TS-950 S / SD/ SDX

Noise Repair Info

SERVICE BULLETIN AMATEUR RADIO

SUBJECT TS-950SD RX DIGITAL NOISE	DATE 01/17/90
--------------------------------------	------------------

FIGURE 1

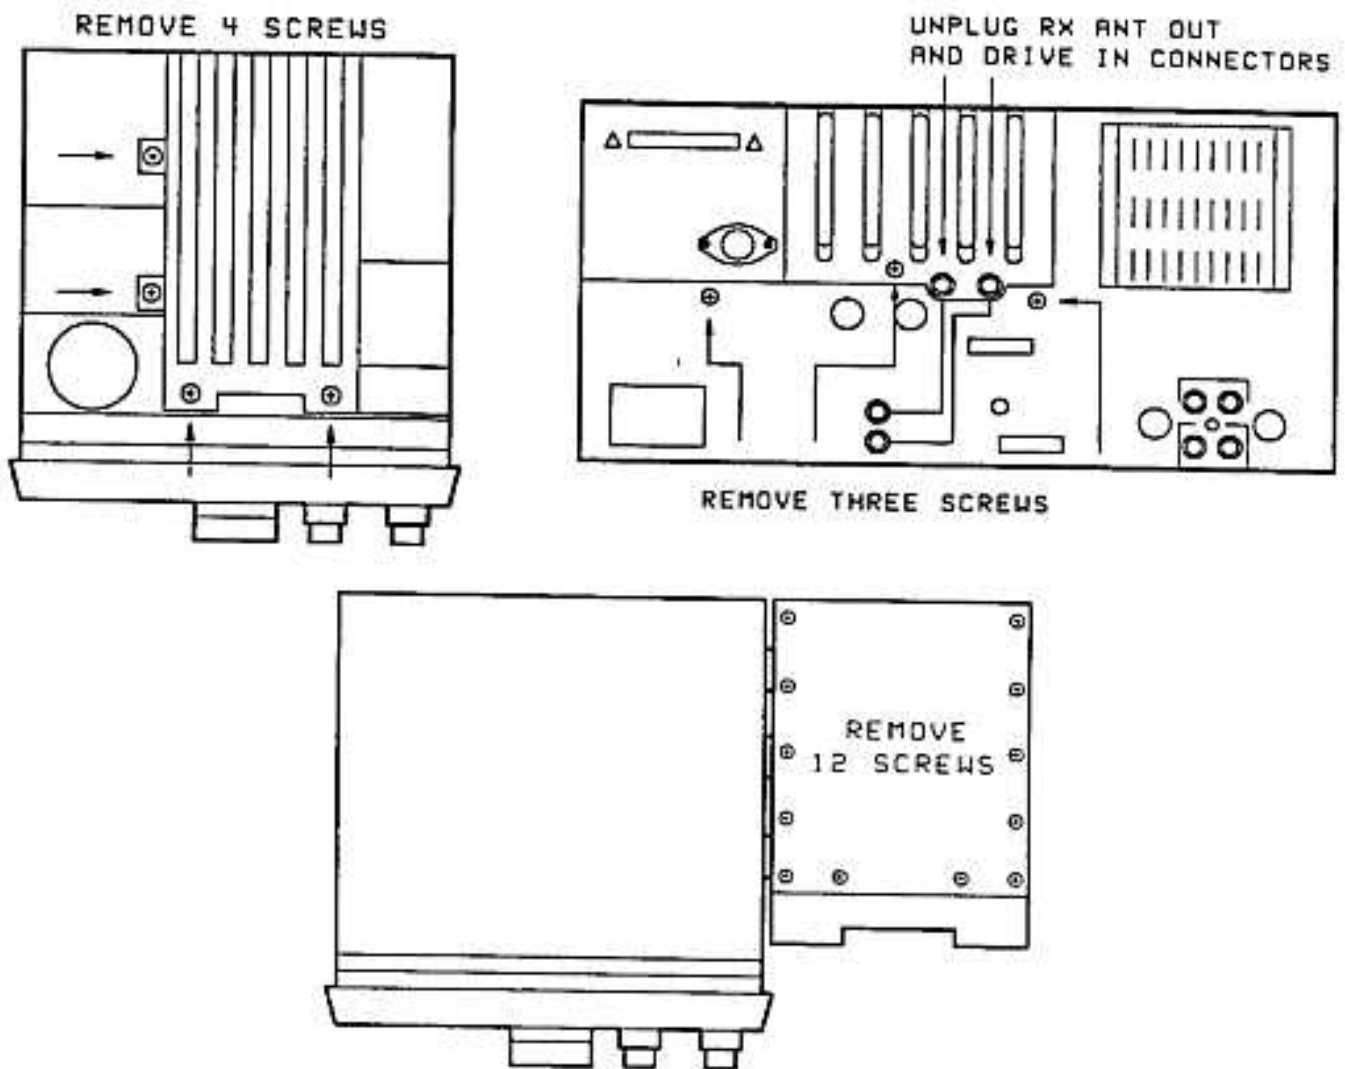
1. Disconnect the power cord and antenna.
2. Remove the top and bottom covers (18 screws).
3. Open the subchassis as shown in figure 1 (remove 4 top screws, remove 3 back panel screws, unplug the RX ANT OUT and DRIVE IN connectors).
4. Remove the cover from the subchassis (12 screws). FIGURE 1.
5. Remove the 9 screws from the Filter board.
6. Desolder the antenna connector wires at the antenna connector. Do not damage the surge absorber.
7. Rotate the Filter unit to expose the foil side of the board. Disconnect coax cables as necessary to rotate the board and remove the mesh plate as the board is rotated.
8. Cut the two ground foils as shown in figure 2.
9. Assemble the transceiver by reversing steps 1 - 7. Remember to install the mesh plate, resolder the antenna connector, and plug in the two connectors on the back panel.

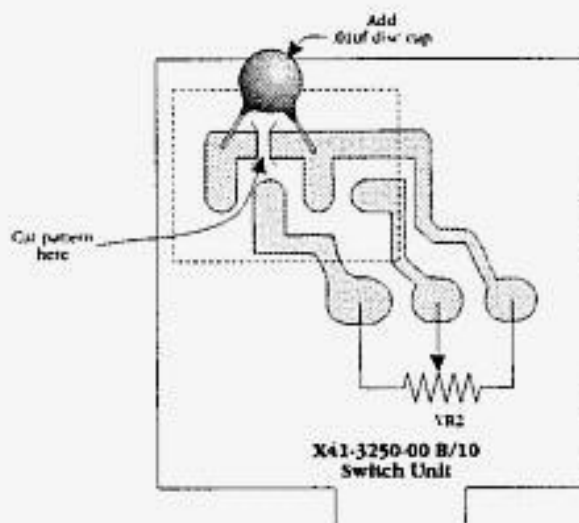
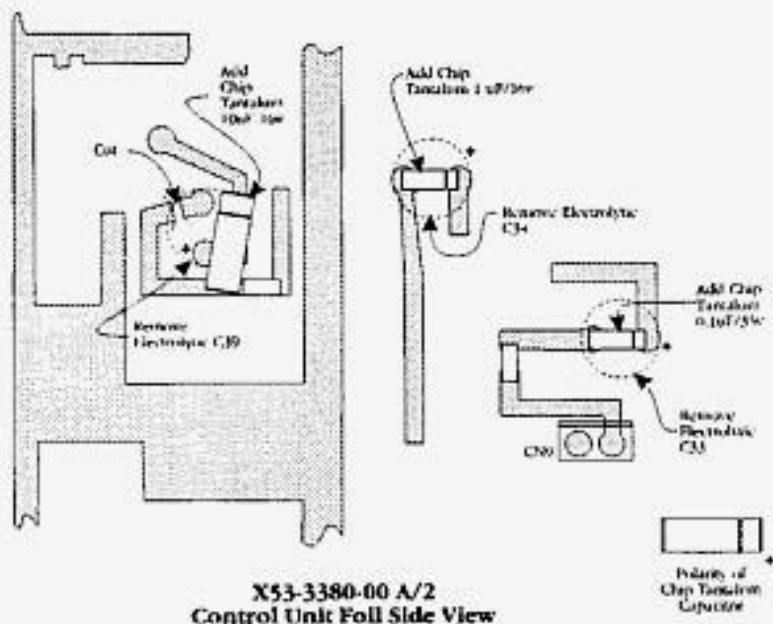
A click noise might be generated when receiving a strong signal (S-9 or above) when the NOTCH is ON and the Notch Control is turned away from the notch point.

Lengthening the AGC release time of the IF Amp just before the NOTCH circuit will correct this symptom. The enclosed modification has been designed to change the time constant only when the NOTCH circuit is activated. Do not install this modification on sets that do not exhibit this symptom as the AGC FAST time constant is affected by this change.

1. Cut the printed circuit foil pattern between the test point (TP) and gate 2 of Q2 as shown.
2. Install the 47 K ohm chip resistor from TP to gate 2 of Q2.
3. Add a 0.047 uF ceramic capacitor as shown in the accompanying illustration.
4. Add the DTC124ES transistor as shown.

Note: The .047 uF capacitor and the digital transistor must be connected together as shown and installed so that they do not touch the surrounding circuit board patterns.

5. Install a jumper wire from the base of the digital transistor to pin number 6 of CN14.

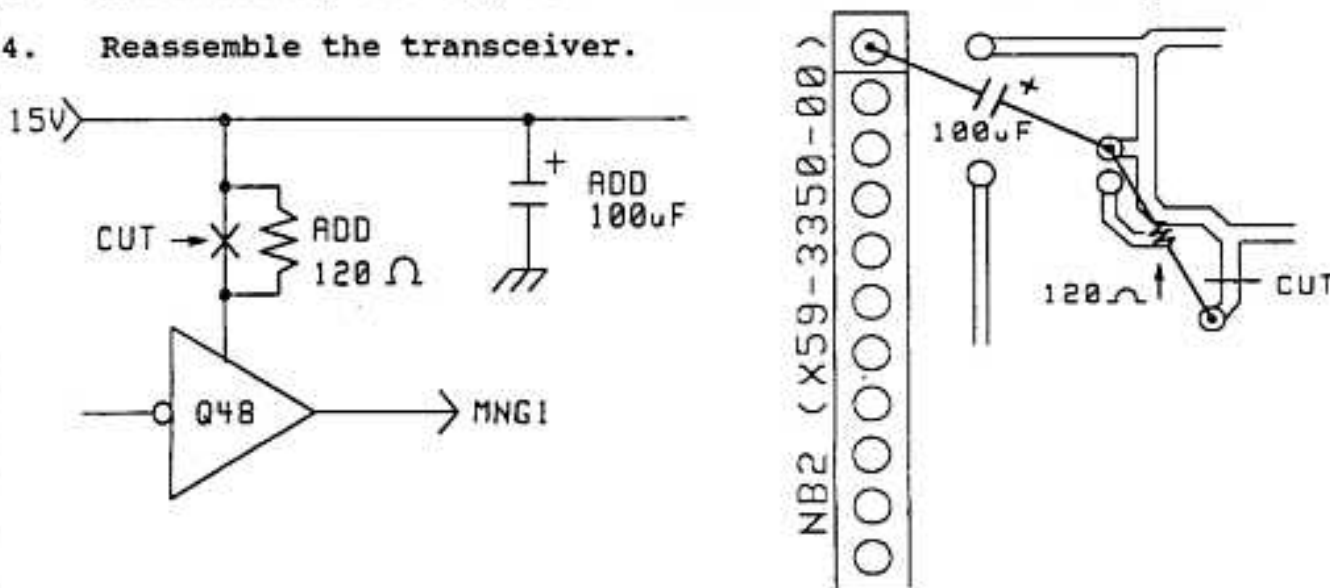
Switching noise from the main band noise blanker circuit may be induced on the 15V line and pass through the AF amplifier to the speaker. The following modification will correct this condition.

1. Cut the foil as shown in the accompanying diagram.
2. Add a 120 ohm resistor between the emitter of Q48 and the 15V line.
3. Add a 100uF, 16V capacitor between the 15V line and ground.
4. Reassemble the transceiver.
